15 February 2022
22204-00

**Subject: Review of Idaho-Maryland Mine Project, Draft Environmental Impact Report,
SCH# 2020070378**

Figure 4-8 of Appendix K.3: Simulated Water Levels Compared to Select Domestic Wells

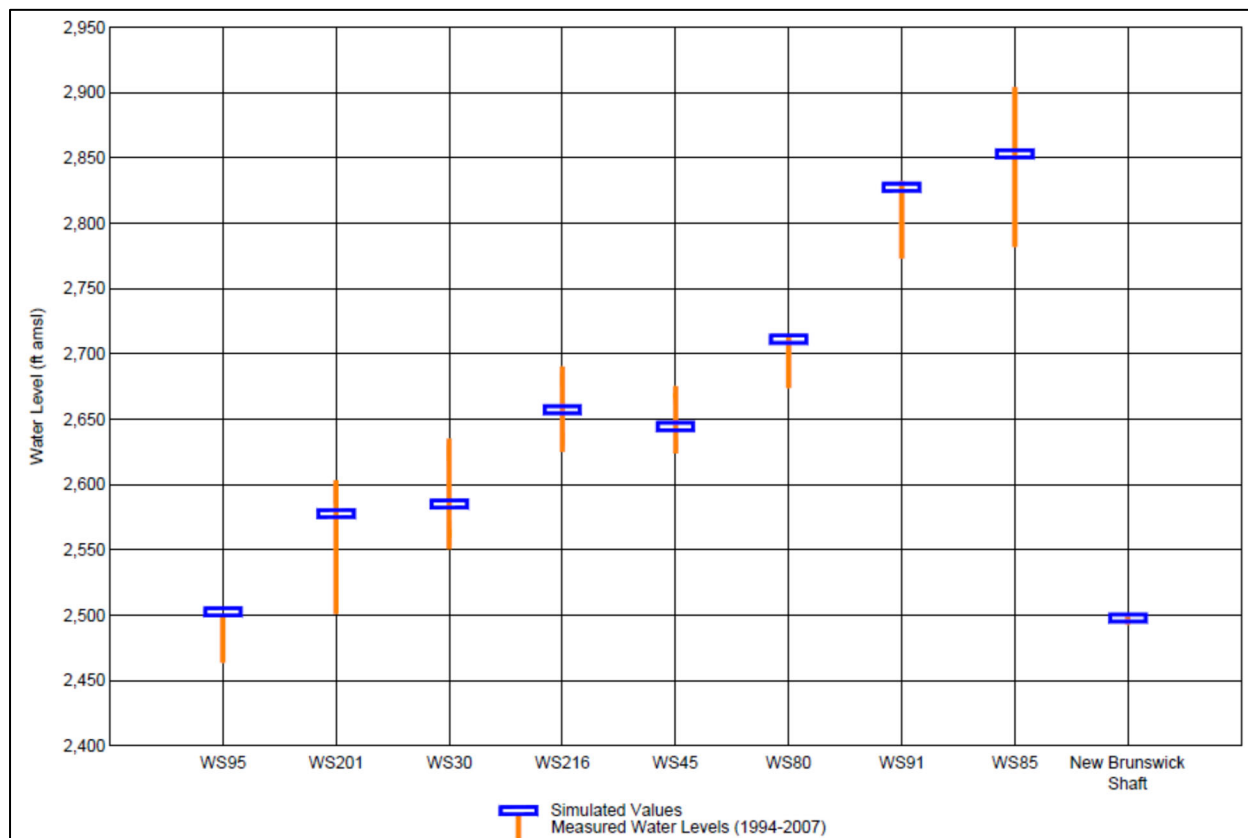
According to groundwater model report in Appendix K.3, the model was further calibrated or verified by terminating the pumps in the historical Idaho-Brunswick Mine (represented in the model by drainage nodes in the mine workings) and allowing the groundwater levels to recover from 1957 to 2019. The simulated groundwater levels at the end of the recovery period (2019) were then compared to water levels measured in eight domestic wells in the project vicinity from 1994 to 2007. As shown in Figure 4-8 from the groundwater model report (see below), the

simulated water levels recovered within the range of measured water levels in the select domestic wells; however, the variation in measured water levels for each domestic well ranges from about 40 feet (well WS95) to 120 feet (well WS85). Demonstrating that the simulated groundwater levels can recover within a 40- to 120-foot range of measured water levels does not provide much assurance regarding the accuracy and reliability of the groundwater model. This is particularly true when the model is being used to predict that the project will have a maximum groundwater level drawdown of 10 feet in the project vicinity.

Figure 4.8-7 of DEIR: Groundwater Movement in Mine Workings (Existing Condition)

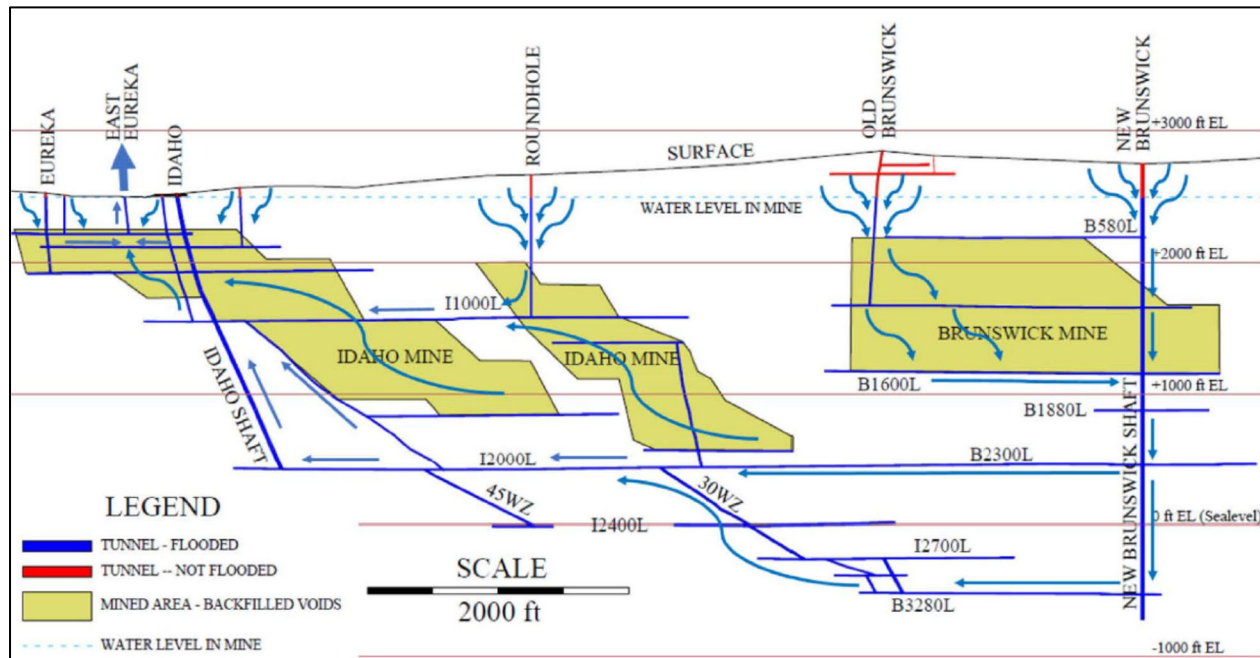
As a result, there is currently a groundwater depression created by constant drainage from the existing mine workings. This groundwater movement is generalized in Figure 4.8-7 of the DEIR shown below. The groundwater model report in Appendix K.3 of the DEIR also simulated this existing groundwater depression. However, the groundwater model report provides no discussion of how this condition was simulated. Since the static water level in the mine workings remains at about 2,497 feet msl, the model should apply boundary conditions (e.g., drainage nodes or pumping wells) along the mine workings located above 2,497 feet msl to create the specified head of the current water level in the mine workings. There is no discussion of such a boundary condition being applied to the groundwater model to simulate the current drainage of the mine workings. Calibrating the groundwater model without incorporating the proper mechanisms to simulate the drainage of groundwater from existing mine workings could introduce substantial error to the overall modeling results.

In summary, there is a high level of uncertainty associated with the groundwater model that was used in the DEIR as justification to identify a very small subset of the domestic wells in the East Bennett area that are likely to be adversely affected by the project, and to characterize impacts to a vast number of other domestic wells in the project vicinity as less than significant. This is a flawed approach and provides no assurance that residences and businesses that rely on groundwater wells in the region will have a reliable water supply if the project were to be approved.
